## **ADDENDUM # 1**

DATE: May 23, 2025  
TO: Potential Respondents  
FROM: Elaine Robbins – Construction Contract Coordinator II  
SUBJECT: RFCSP752-25-1010ER  
UNT Discovery Park D170 Research Lab Buildout

## ADDENDUM NO. 1

**PROJECT:** UNT Discovery Park D170 Fit-Out  
HE0569.2402.00

UNT STANDARD SIGNAGE A3

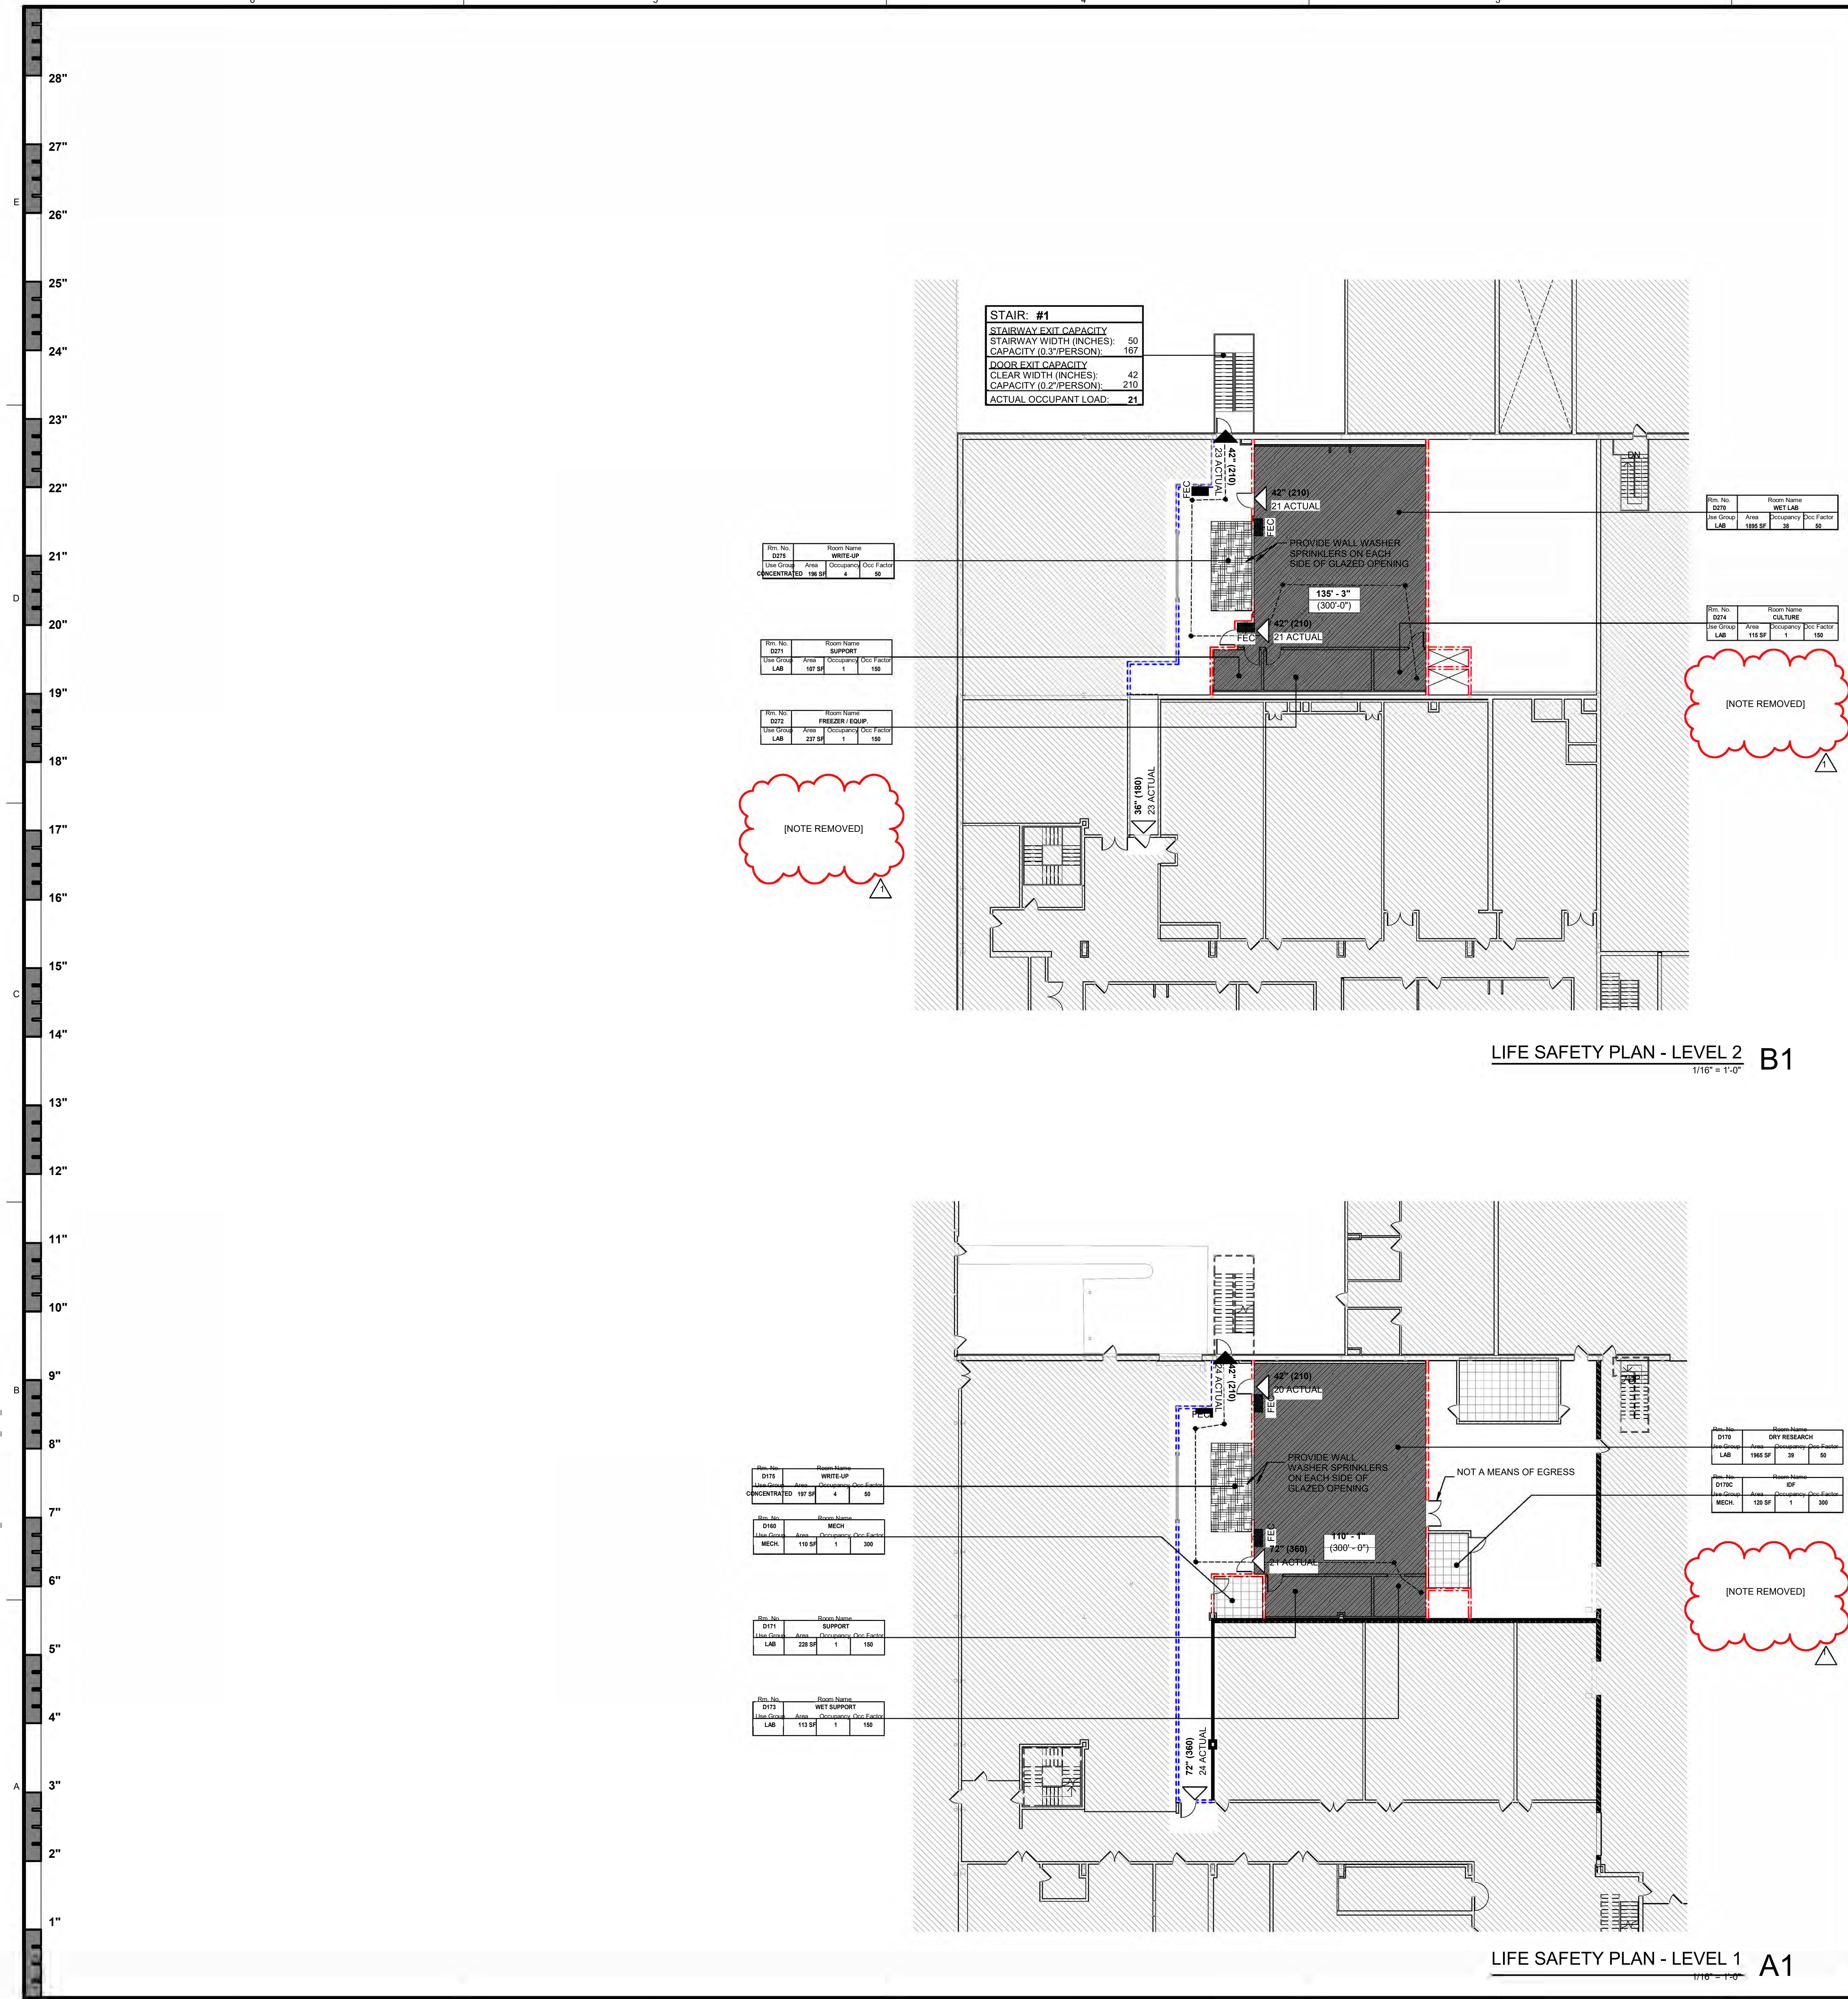
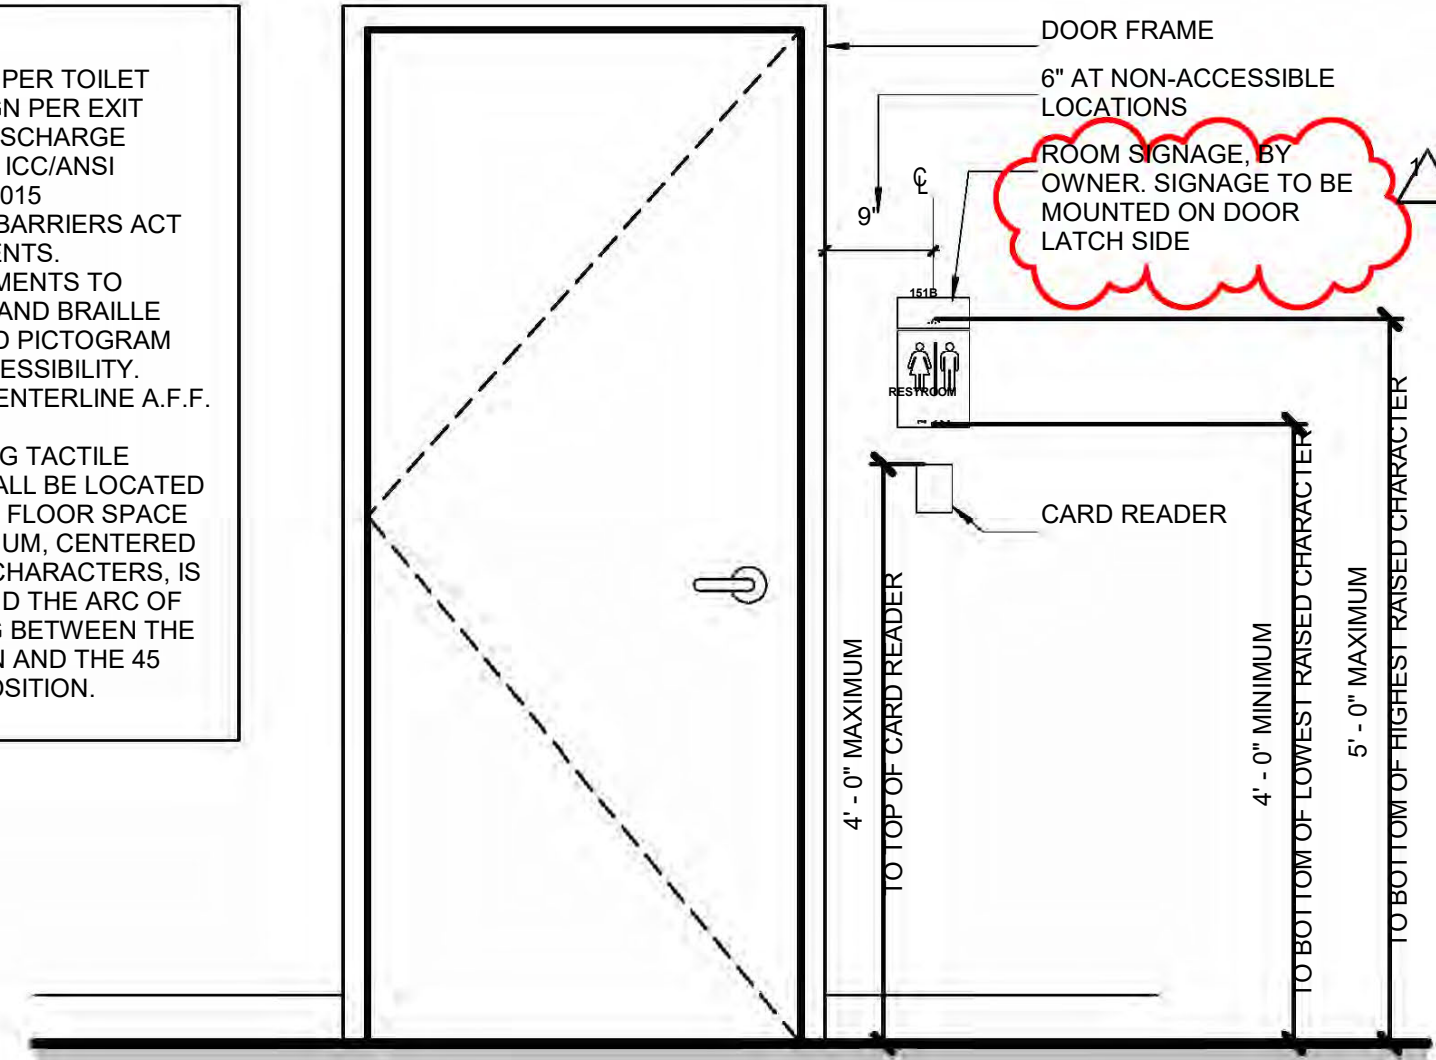
ITEM	DETAIL
	<b>BIDDER QUESTIONS</b>
1.1	Q: G005, Spec 10.1423 - Typical Room Signage detail on G005 references Sheet A611A for signage details and schedule. Sheet A611A is not included in the IFC Drawing Set. Please provide information on signage details and schedule if the scope should be included by CM. A: <b>Room signage will be Owner provided and installed</b>

1.23	<p>Q: Signage - I cannot seem to find the additional info on the signage. It says it's on page A611A, but that page is not there. Can you please advise?</p> <p>A: <b>Room signage will be Owner provided and installed. Note on G005 has been revised.</b></p>

1.79	<u>Sheet G005 – ACCESSIBILITY AND SIGNAGE STANDARDS</u> Note on A1/G005 revised to clarify room signage is by Owner.  <u>Sheet G101 – CODE AND LIFE SAFETY PLANS</u> Note about existing fire rated walls removed.  <u>Sheet S2.01 – FOUNDATION PLAN</u> Column gridline 64.5 renamed to 64.2 to match Architectural.

S2.02

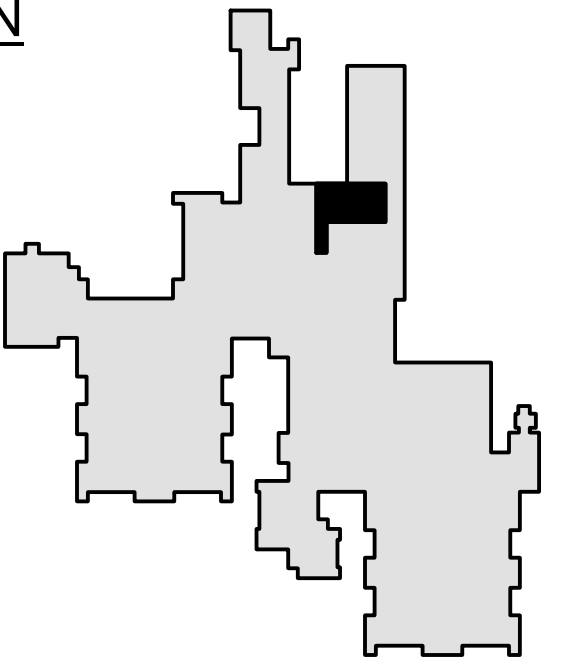
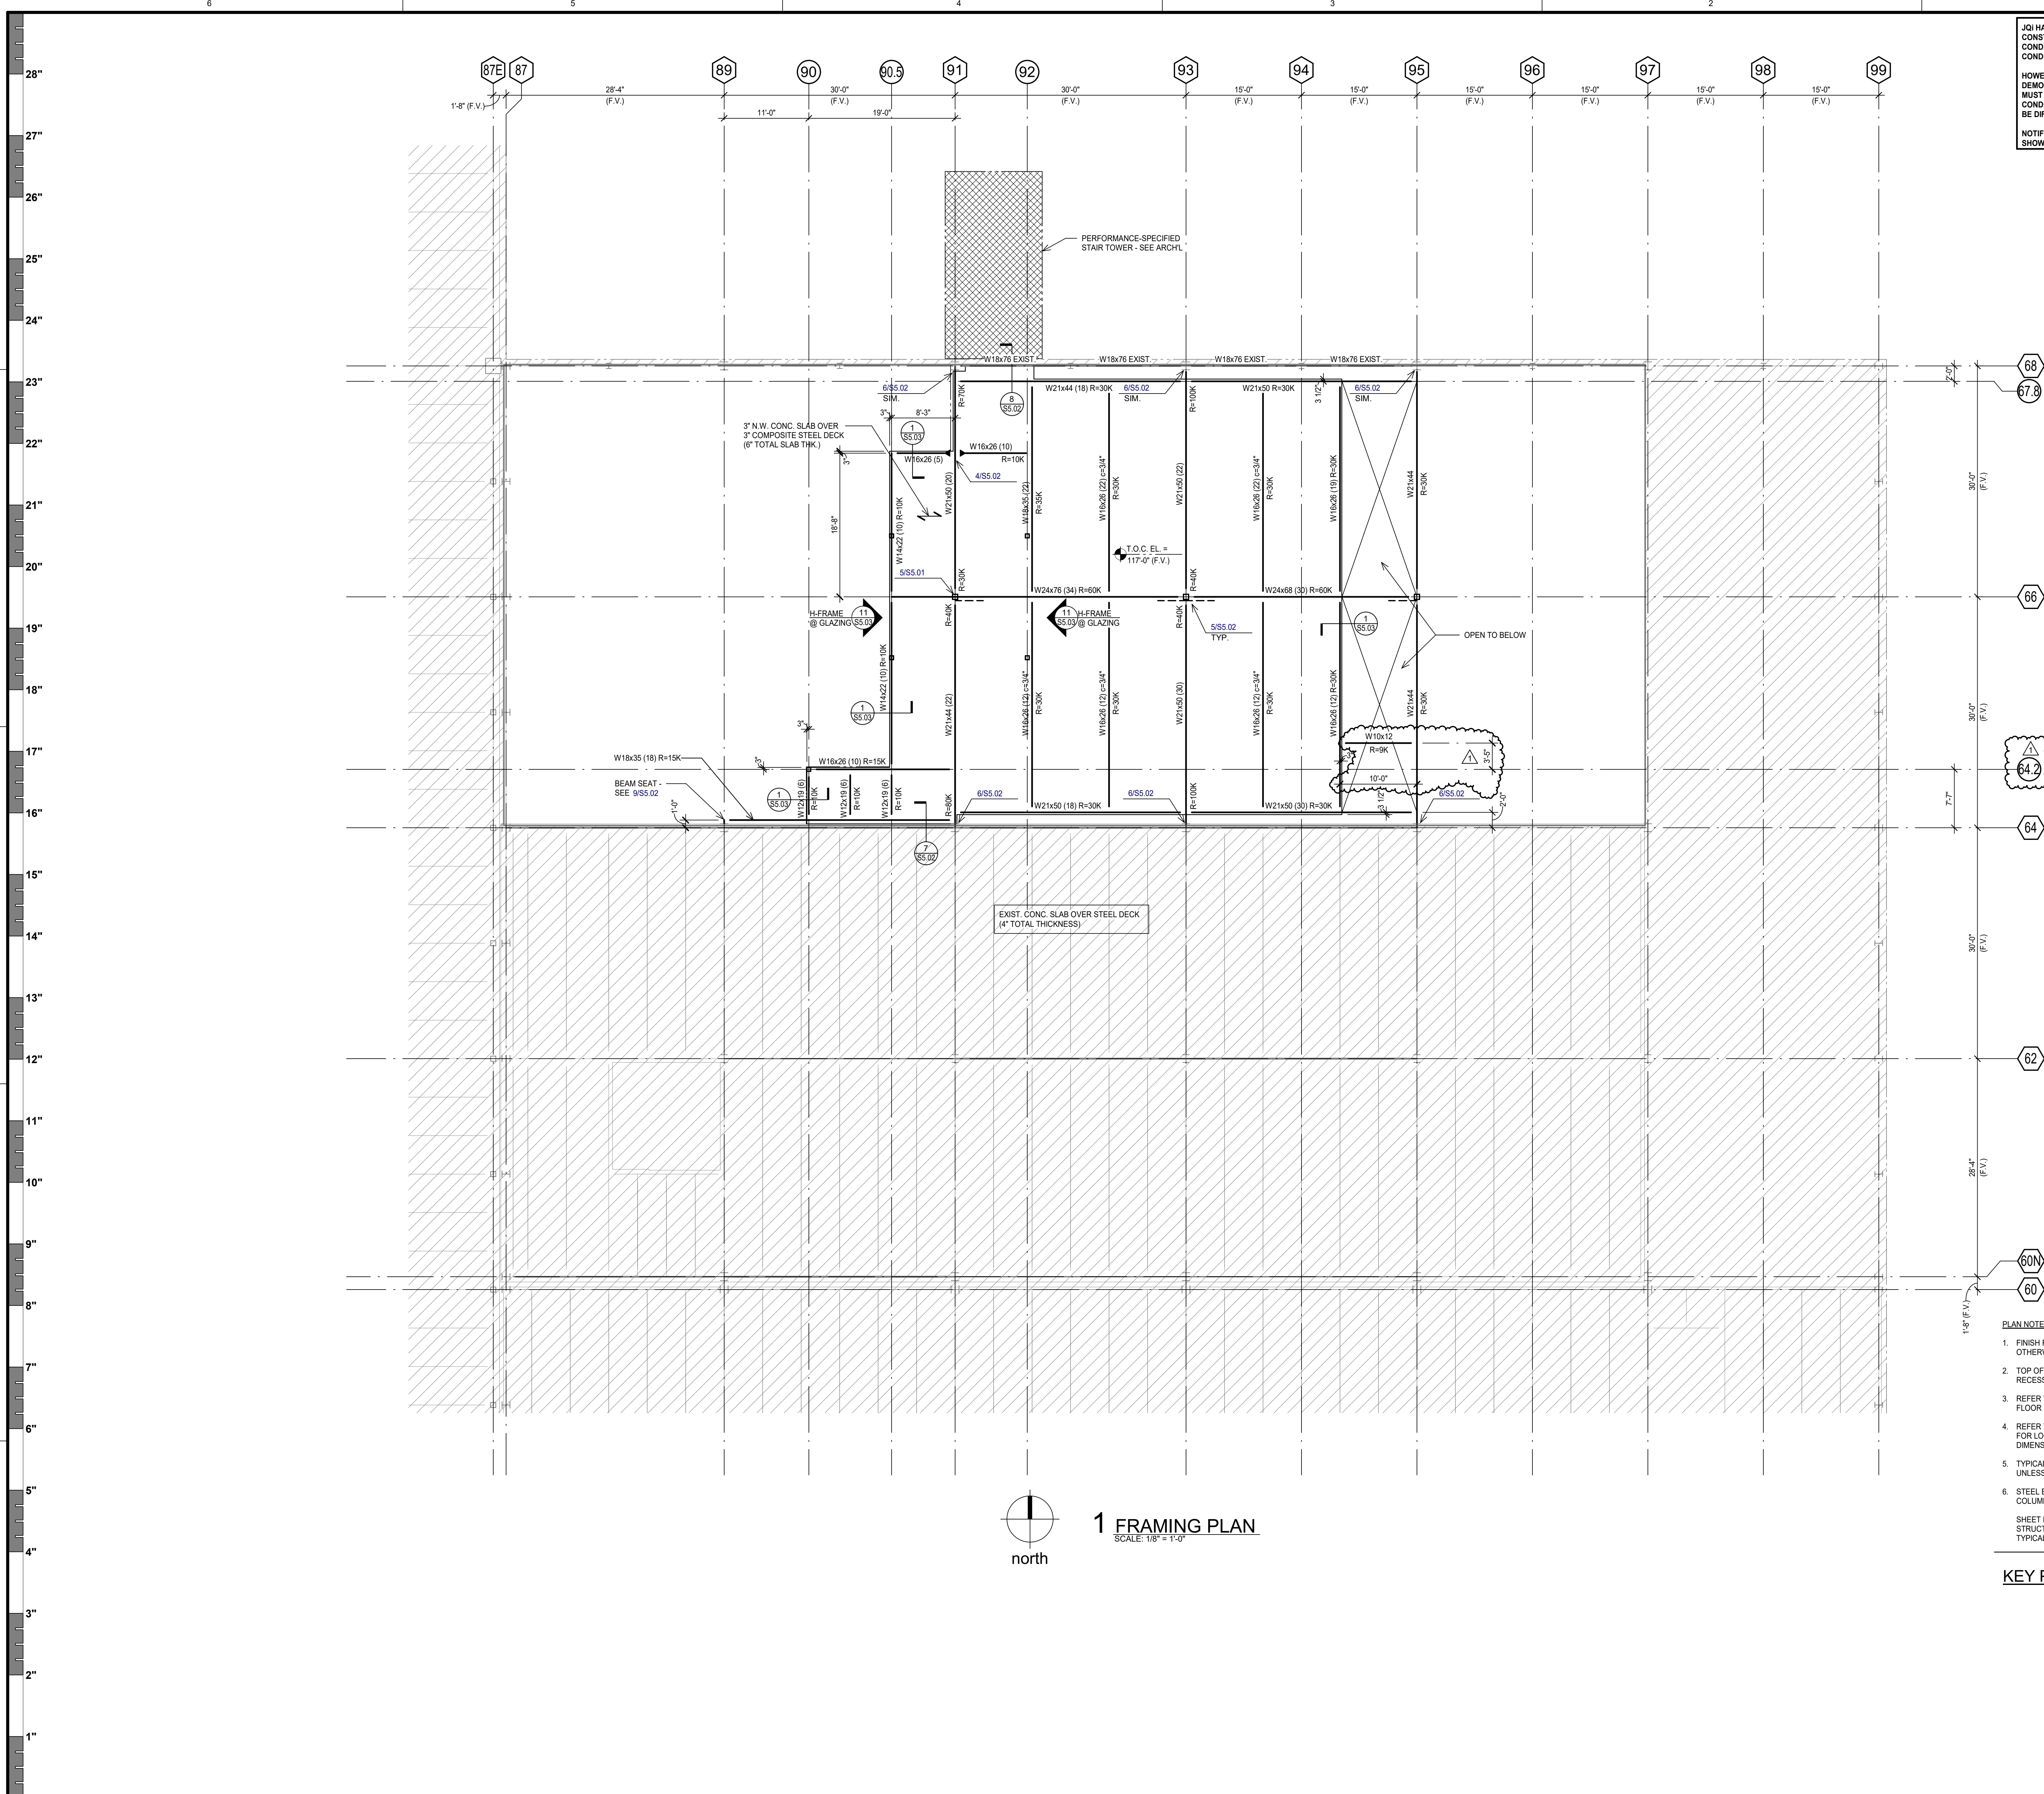
1.62	<p>Q: The north and east X6-1 walls shown north of column line 64.2 and east of door D274 creates a mechanical shaft that is to sit on top of IDF room D170C. There is no structural deck above the IDF D170C to support these partitions. Please clarify how this shaft is to be constructed and provide a cross-section detail showing how the X6-1 partition is to be supported above the IDF.</p> <p>A: <b>Structural framing is updated in this addendum to support shaft wall</b></p>

ITEM	DETAIL
	<p><u>Sheet S2.02 – FRAMING PLAN</u> Column gridline 64.5 renamed to 64.2 to match Architectural. W10x12 beam added to support the level 2 shaft wall partition.</p> <p><u>Sheet S2.03 – ROOF FRAMING PLAN</u> Column gridline 64.5 renamed to 64.2 to match Architectural.</p> <p><u>Sheet A101 – FLOOR PLAN – LEVEL 1</u> General note “L” has been removed.</p> <p><u>Sheet A102 – FLOOR PLAN – LEVEL 1</u> Wall type, dimension by fume hoods clarified. General note “L” has been removed.</p> <p><u>Sheet A151 – REFLECTED CEILING PLAN – LEVEL 1</u> Light fixtures in room D160 updated to match Electrical. Outlet locations updated in linear ceiling service panels.</p> <p><u>Sheet A152 – REFLECTED CEILING PLAN – LEVEL 1</u> Outlet locations updated in linear ceiling service panels. Ceiling supply diffuser locations updated.</p> <p><u>Sheet A501 – INTERIOR DETAILS</u> Detail C1/A501 updated to clarify card reader rough-in at doors.</p> <p><u>Sheet A601 – DOOR SCHEDULE, GLAZING TYPES, AND DETAILS</u> Glazing notes updated to reflect clear tempered glazing as opposed to laminated glass. Door finishes updated on all SCW interior doors. Door lite light in type “N” door has been dimensioned.</p> <p><u>Sheet A700 – INTERIOR FINISH SCHEDULES AND DETAILS</u> Acoustical Panel Ceiling product basis-of-design has been revised. LGL-1 revised to be GL-1, reflecting clear tempered glazing as opposed to laminated glass. TS-1 revised to VPUL 50 ACGB. WD-1 wood veneer added as door finish on interior SCW doors.</p> <p><u>Sheet A710 – FINISH PLAN – LEVEL 1</u> Note P18 revised to reference the correct detail. Corner guards added to gyp framed wall opening.</p> <p><u>Sheet A711 – FINISH PLAN – LEVEL 2</u> Keynote legend added to sheet.</p> <p><u>Sheet A805 – LINEAR SERVICE PANEL DETAILS</u> Linear service panel outlet locations and quantities adjusted.</p>
